# Part IV of January 18, 2017 PZC Agenda Packet

TO: Planning & Zoning Commission  
FROM: Heather Valone, Village Planner  
THRU: Jeffery Stein, Deputy Village Administrator  
SUBJECT: Case 14-12 Donegal Excavating PUD  
DATE: January 4, 2017

Case No. 14-12  
Project Name Donegal Excavating

REGISTERED LANDSCAPE ARCHITECT  
 TIMOTHY PULLOWY  
 157-001200  
 State of Illinois  
*Timothy P. Pollowy*  
 exp. 08/31/2017

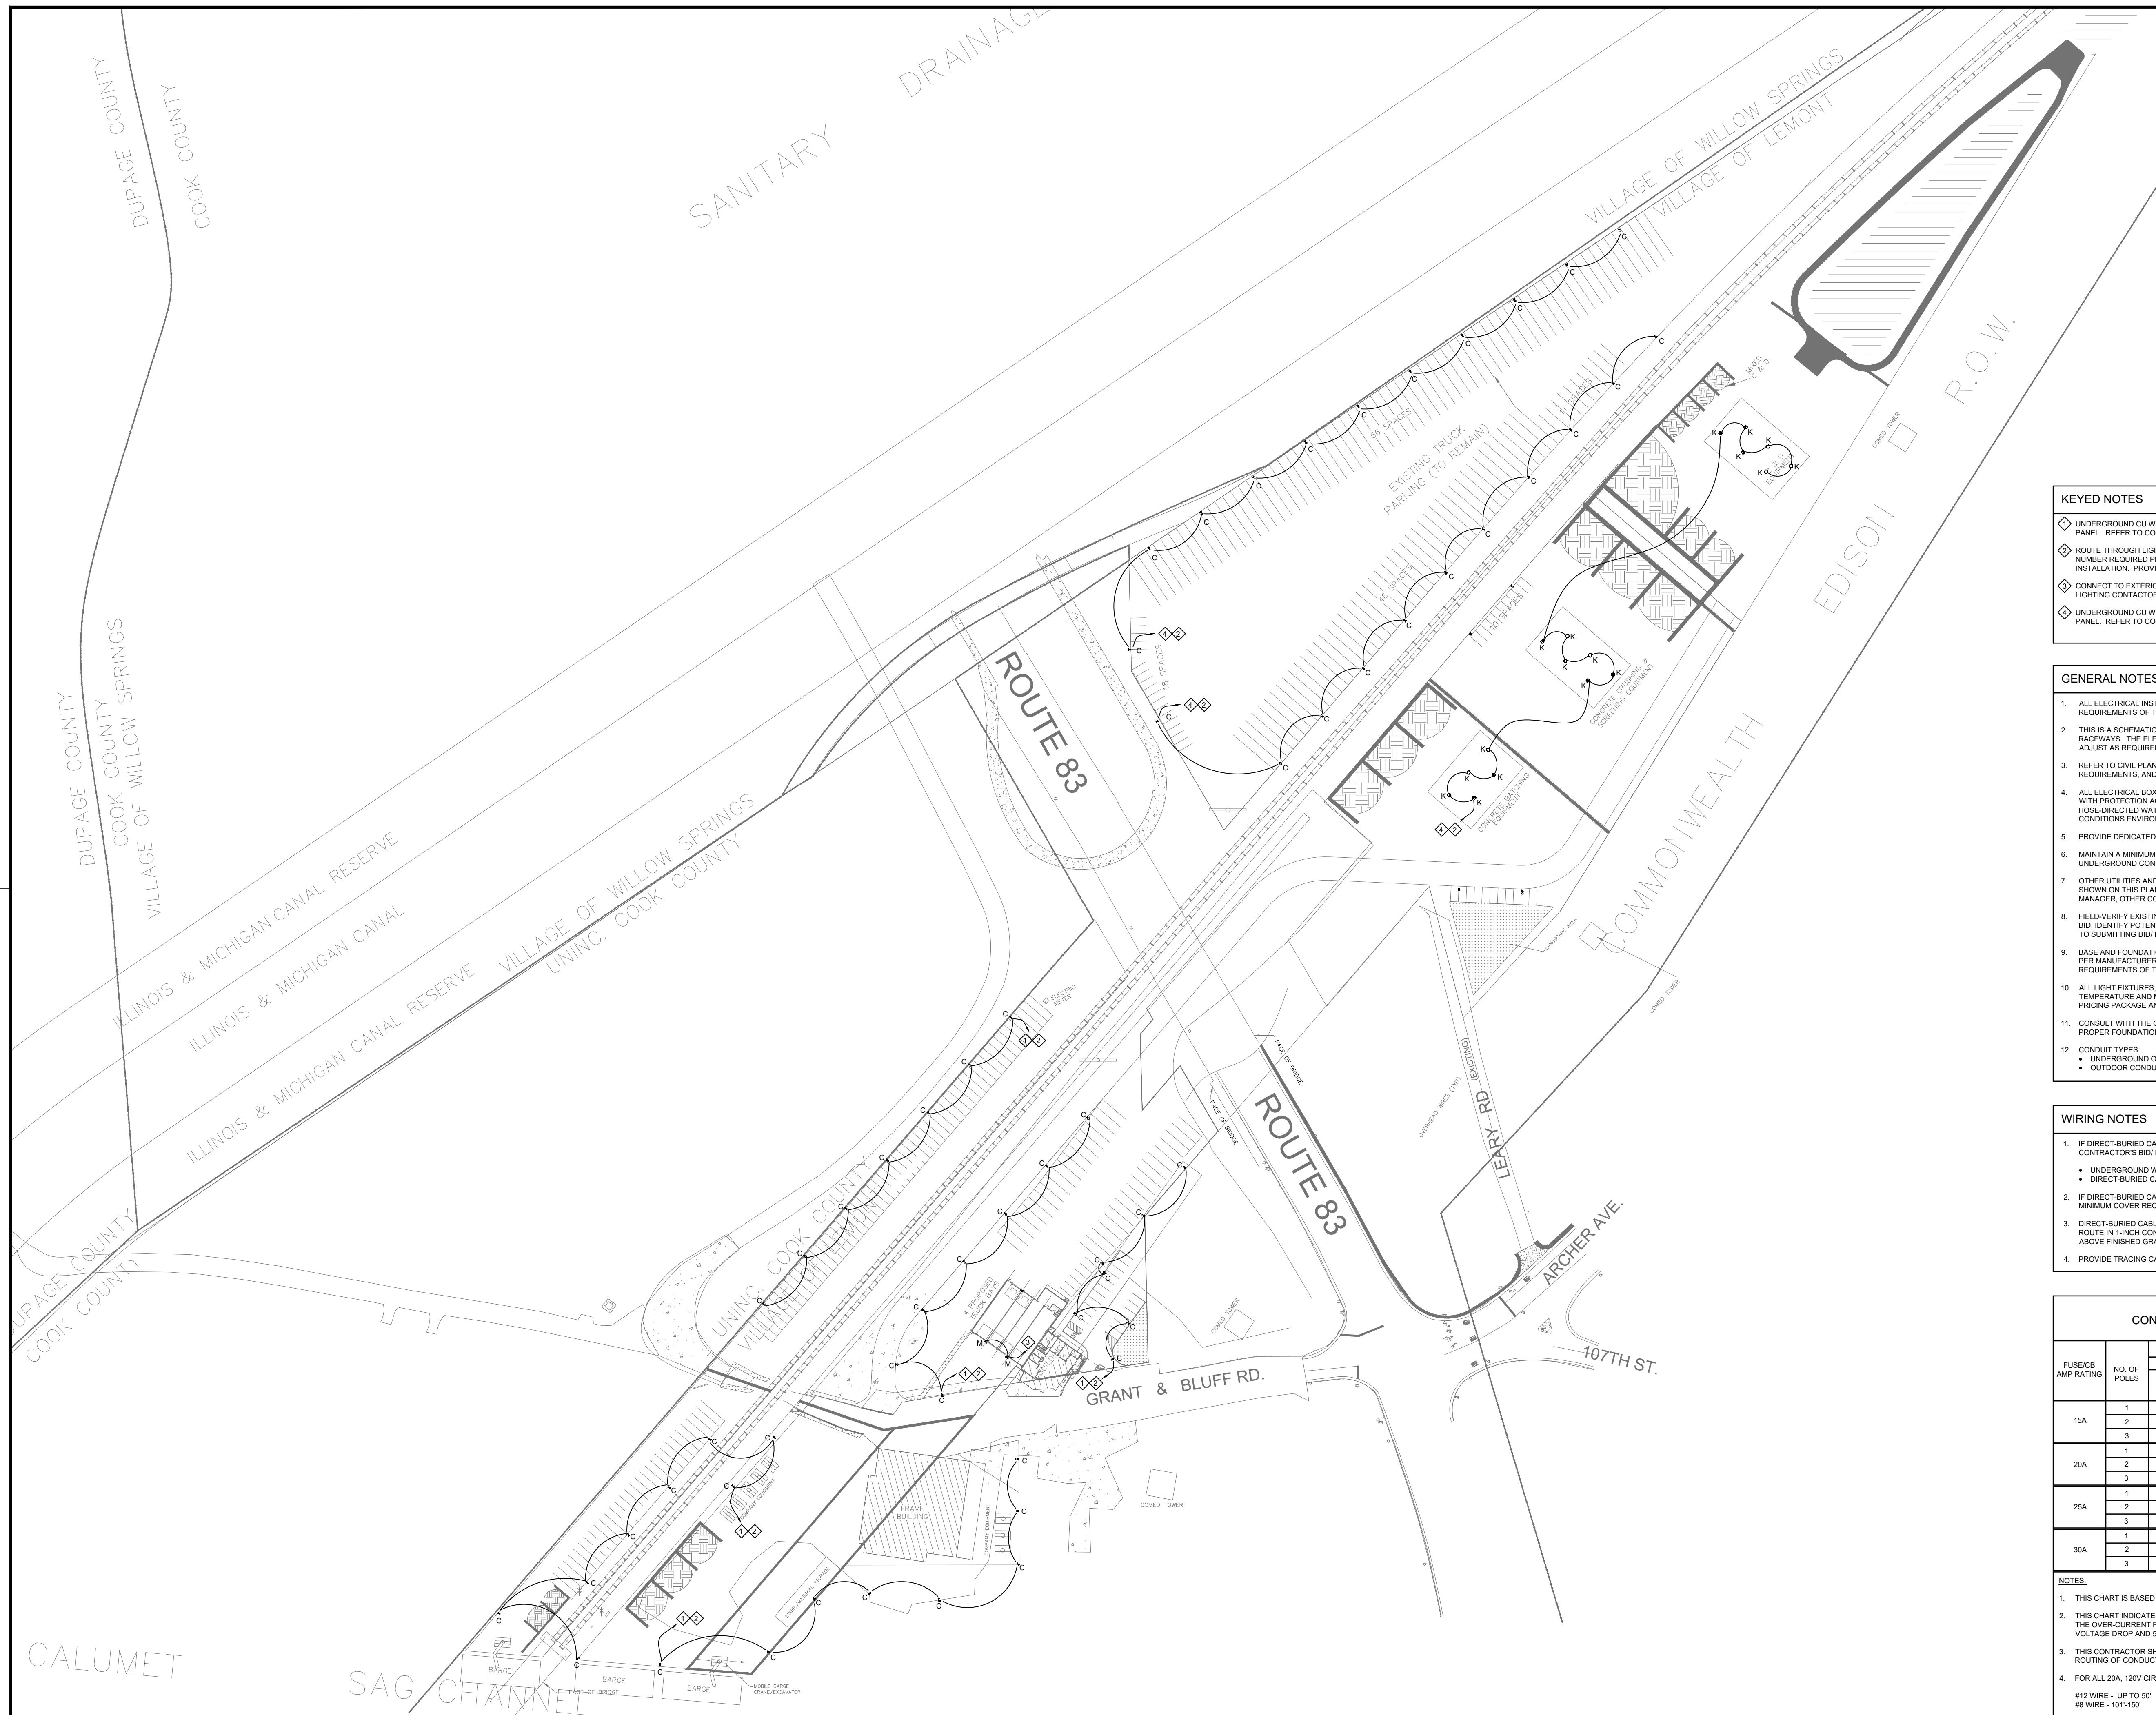
The landscaping plan and the engineering plans depict different amounts of landscaping along the private road through the box culvert. These plans must be revised to be consistent with one another and not contradictory to each other.

The Village Arborist reviewed the application and noted that the proposed plants are suitable for the industrial sight. There are deficiencies in the employees' parking lot landscaping which should be revised. The Village Arborist had no concerns with the use of fencing along the railroad tracks being used in lieu of landscaping along the parcels north of the tracks. Information on the existing trees is missing and requested by the Village Arborist to be included on the landscape plans.

1. The landscape plan notes indicate that all existing trees will be retained. There are three tree symbols on the existing conditions plan, but there was no information as to the species size and condition of the trees. The landscape plan shows one 36" D.B.H. tree to remain. The species and condition of the tree were not provided.

2. The landscaping opportunities for this site are limited. The landscape plan is generally suitable to the site. The proposed landscaping for the storm water detention area is not consistent with landscape standards in Section 17.20.080 of the Village Ordinance.

3. The use of fencing along the north side of the railroad ROW instead of landscaping for the truck and equipment parking is acceptable. The landscaping in the normal employee parking lots must be revised to increase the landscaping and landscaped islands.

3. Revise the landscaping plan to include at least one (1) plant unit per 100 ft. of frontage along Grant Rd. and Leary Rd.
4. The landscape plans must also be updated to increase the landscaping around the exterior of the employee parking area.

5. Incorporate 595 sf. of landscaped islands between the employee parking area and the truck/equipment parking area on Lot 2.
6. Update the engineering plans and the landscape plans to show the same landscaping and fencing information and show a fence along the railroad ROW on Lot 6.

### ELECTRICAL SITE LIGHTING PLAN

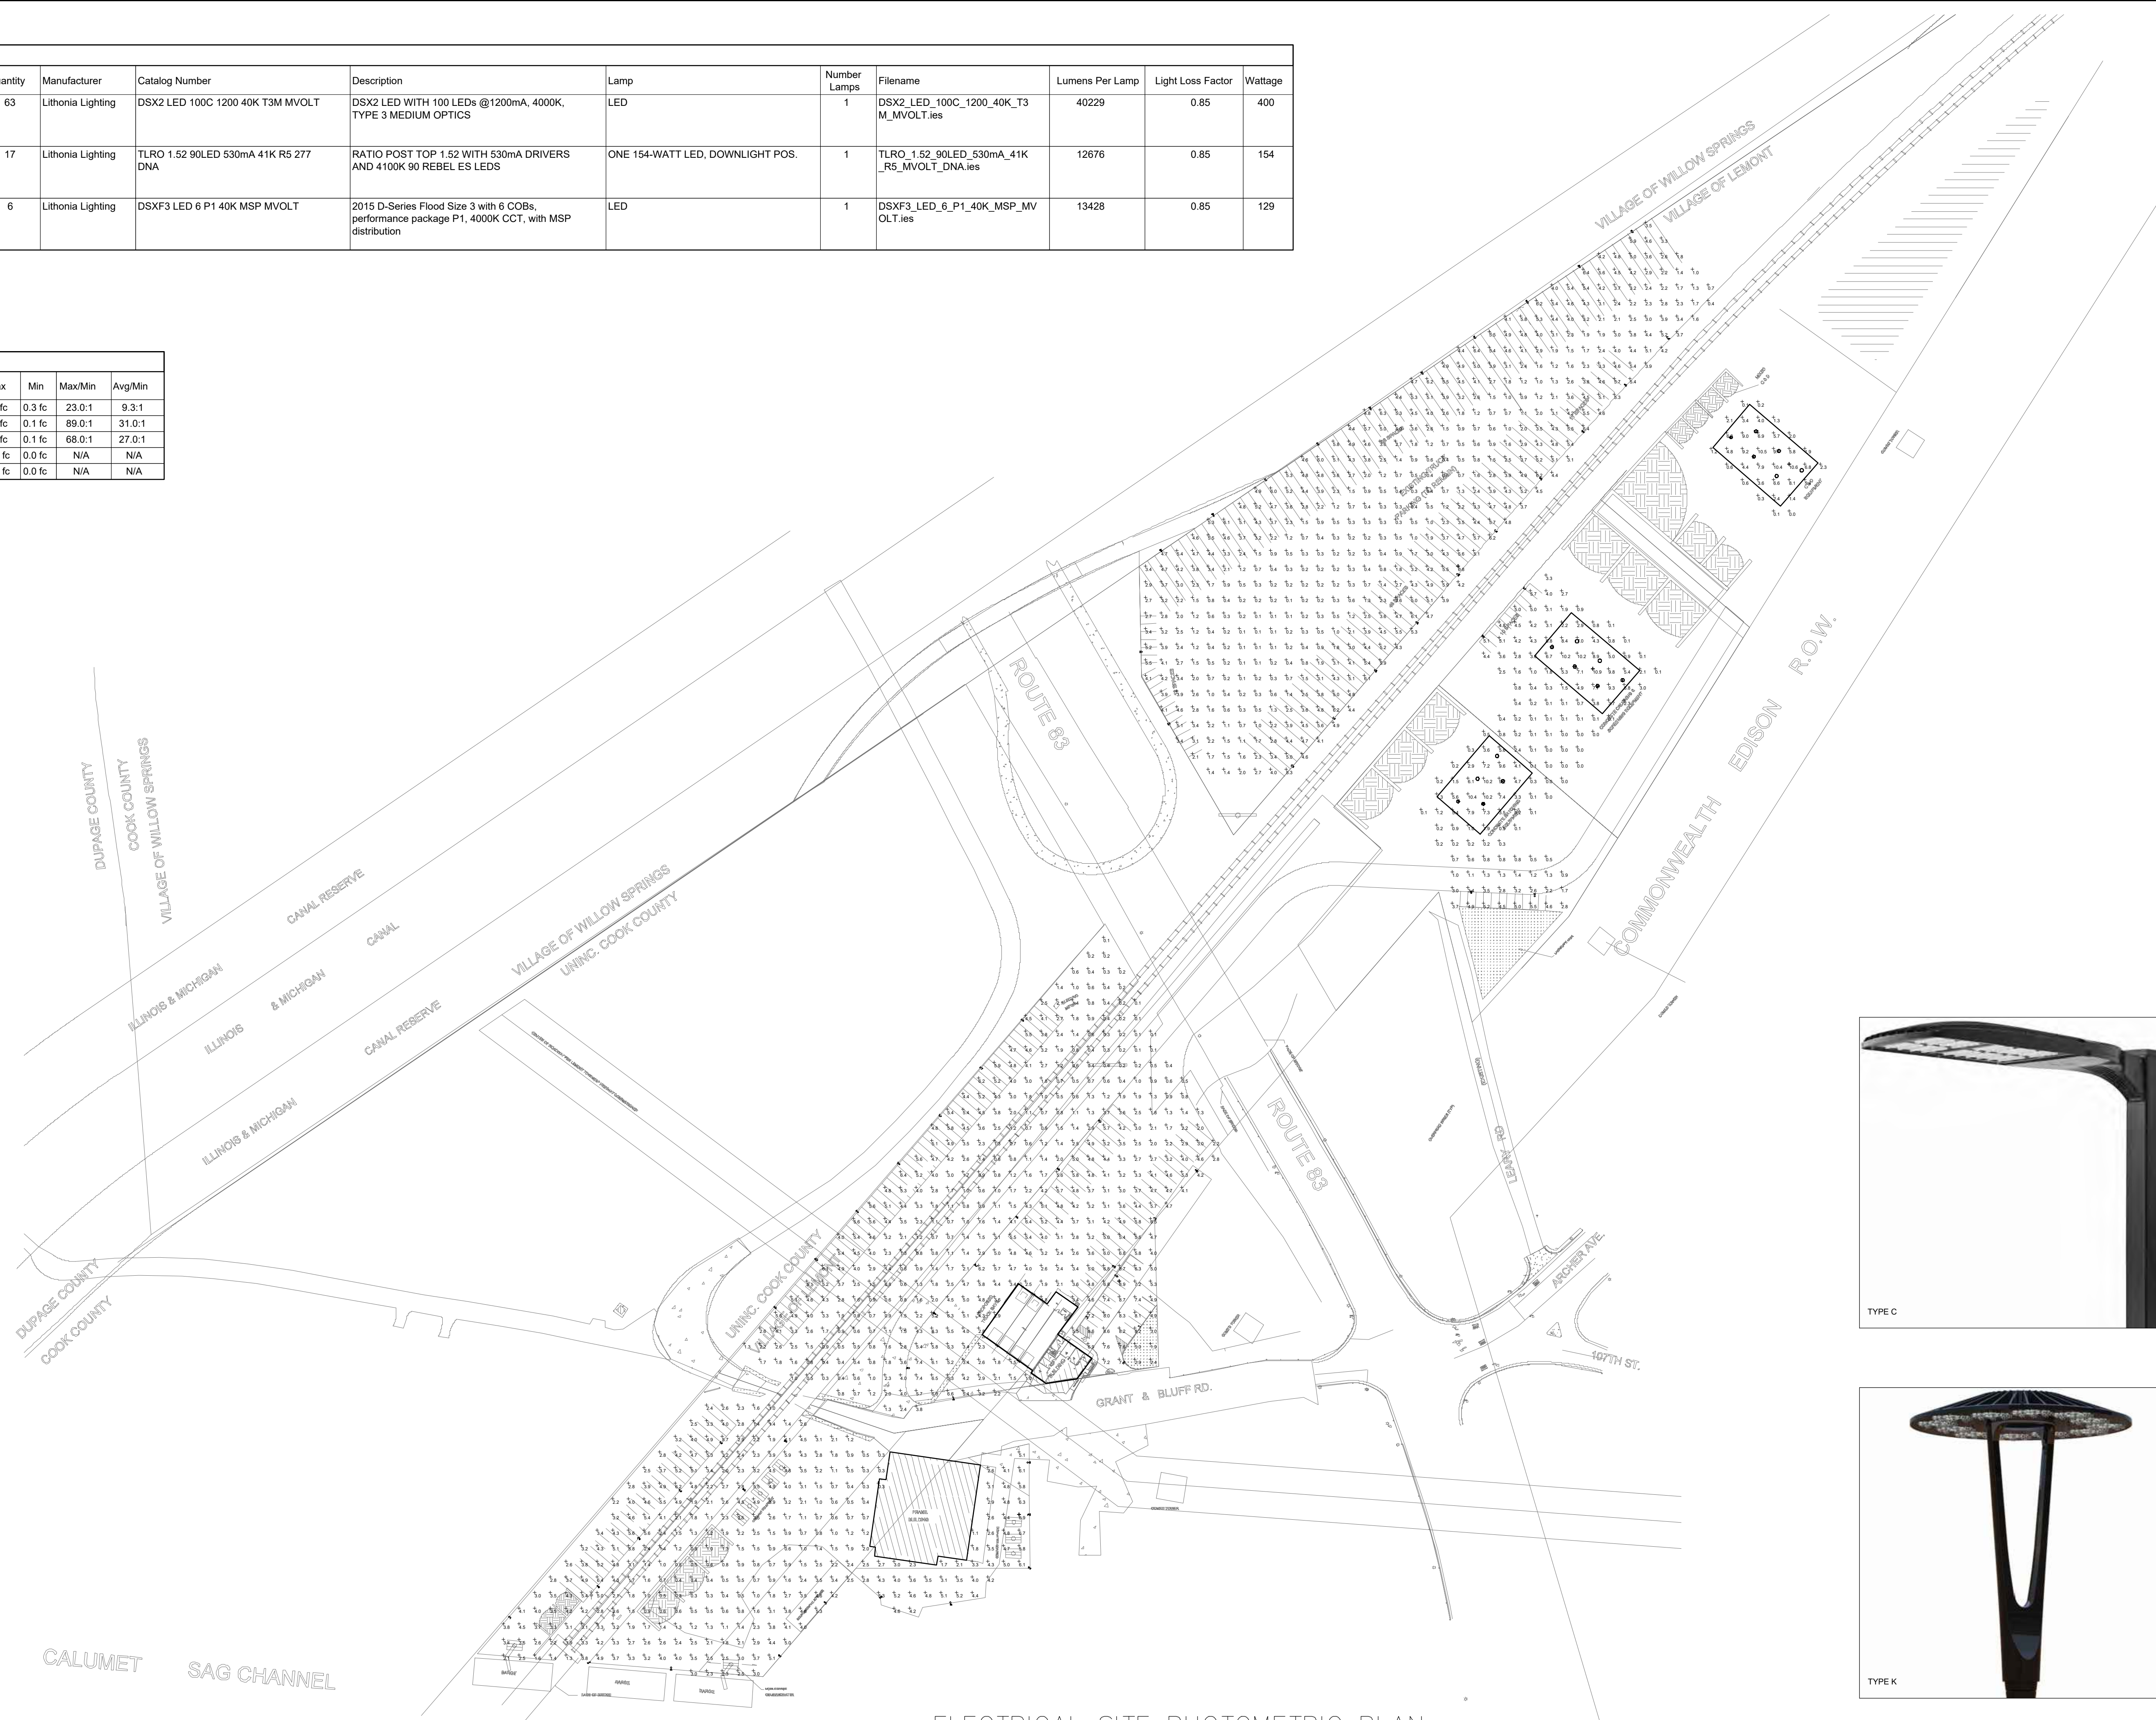
5. The street lighting plan needs to be revised to comply with Village Standards.
  - No flood lights are allowed.
  - Luminaire must be horizontal mount, and because they are LED, have glare shields.

7. Provide information on the proposed sound levels to determine if it meets UDO standards.
8. Revise the photometric plan to not exceed five (5) footcandles at the property lines, extend all footcandle calculations just past the property lines, and remove the lighting that is proposed outside of the subject property.
